Amendments to the Drawings:

Remarks

FIG. 13

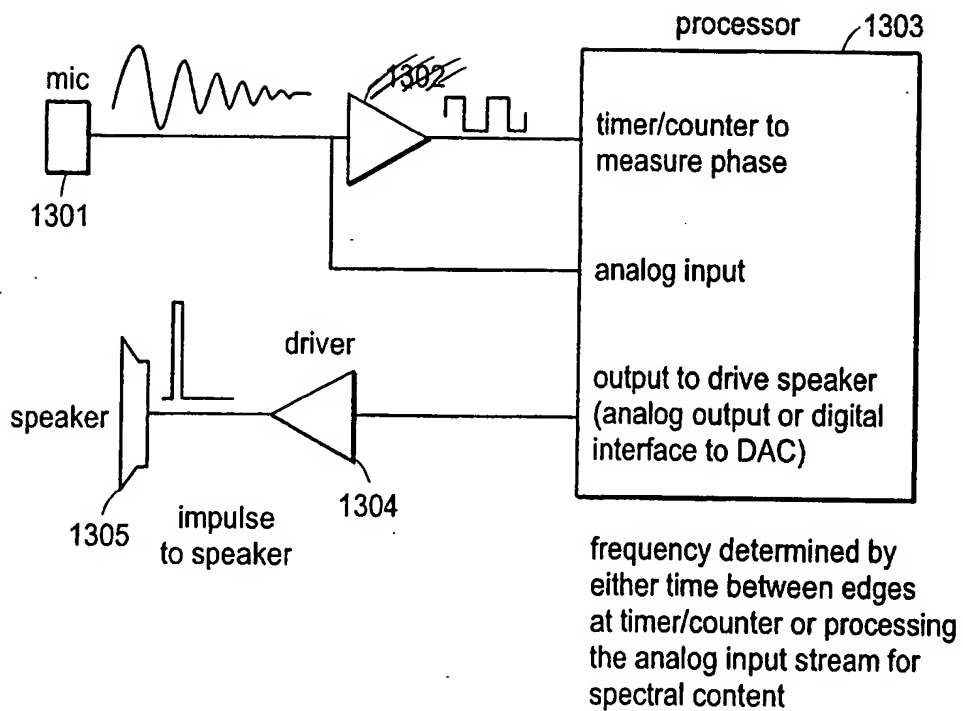
In Fig. 13, superfluous label 1302 has been removed.

FIG. 1

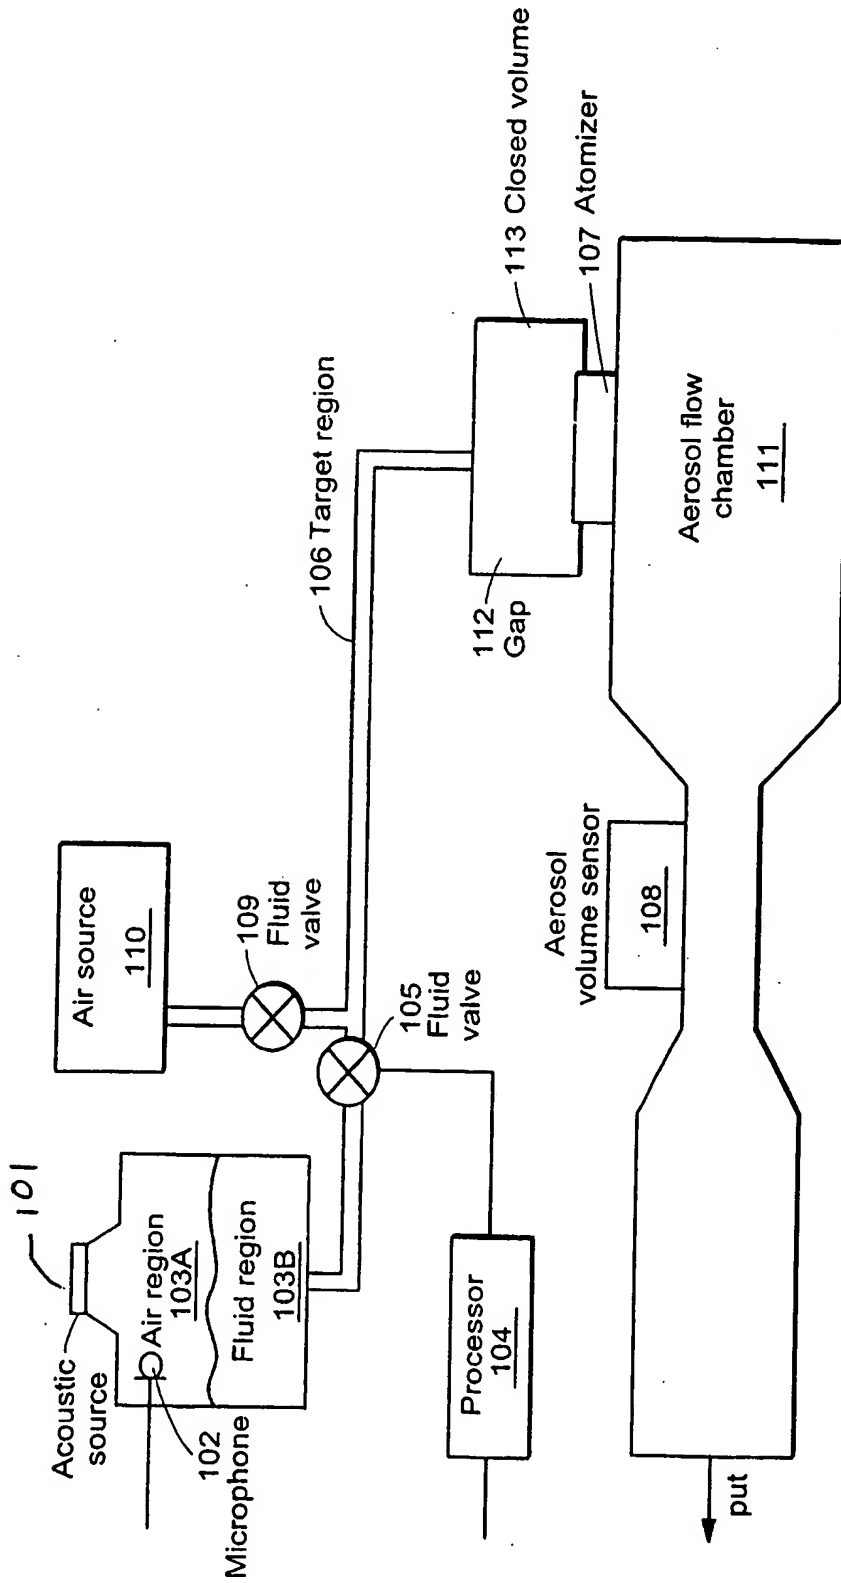
In Fig. 1, the acoustic source **101** has been labeled, per the text.

FIG. 5C

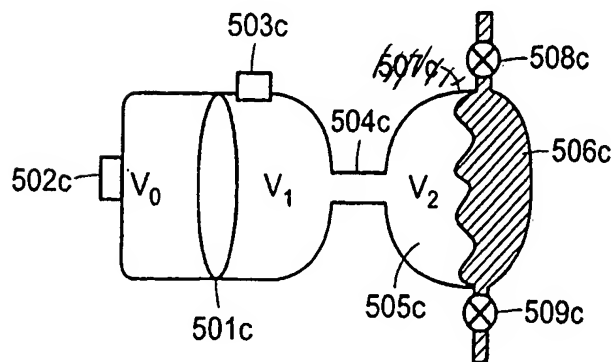
In Fig. 5C, superfluous label 507c has been removed.

FIG. 8

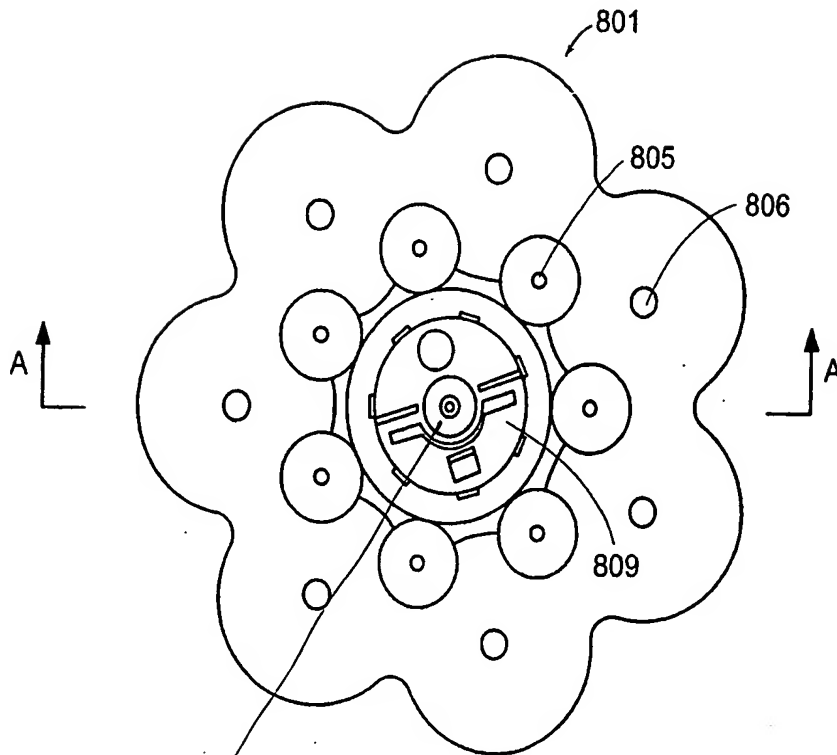
In Fig. 8, valve **807** has been labeled.

FIG. 11

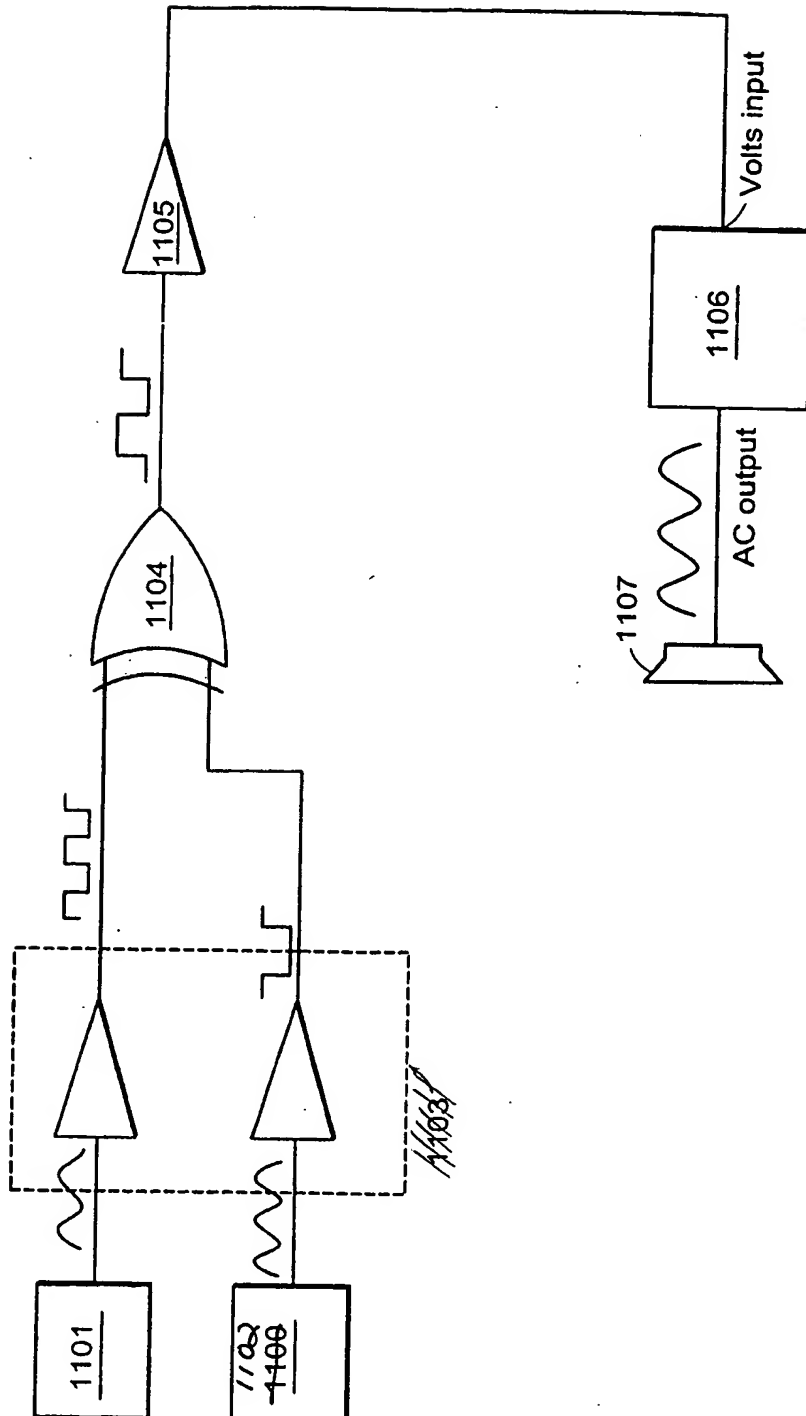
In Fig. 11, reference number **1102** is now correctly presented, and superfluous label 1103 has been removed.
